## <u>Urgent Field Safety Notice</u> <u>Tourni-Cot Universal – "Uni-Cot"</u>

### 1. Information on Affected Devices\* 1. Device Type(s) 1 Tourni-Cot - Universal: This is an exsanguinating digit tourniquet. It is the universal size of the Tourni-Cot family of products. It is supplied sterile. 2. Commercial name(s) Uni-Cot, TCU 3. Unique Device Identifier(s) (UDI-DI) 1 00855364004085 4. Primary clinical purpose of device(s)\* 1 Digital tourniquet used to exsanguinate when applied and occlude blood flow. 5. Device Model/Catalogue/part number(s)\* 1 TCU-6001 1 6. Affected serial or lot number range All units 1 7. Associated devices None

FSCA Ref: MM-FSA-01

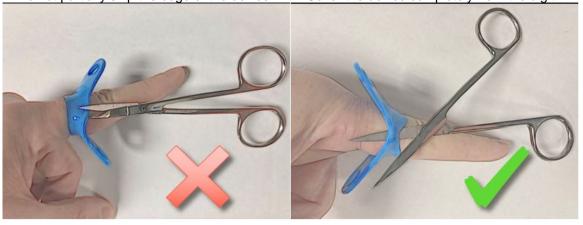
The manufacturer believes that this failure can be largely mitigated by following standard best practices for the use of tourniquets, specifically by reviewing the affected digit for complete removal of device prior to completion of the procedure. See images below for guidance:

Do not partially snip the edge of the device. Sever the device completely from the digit.
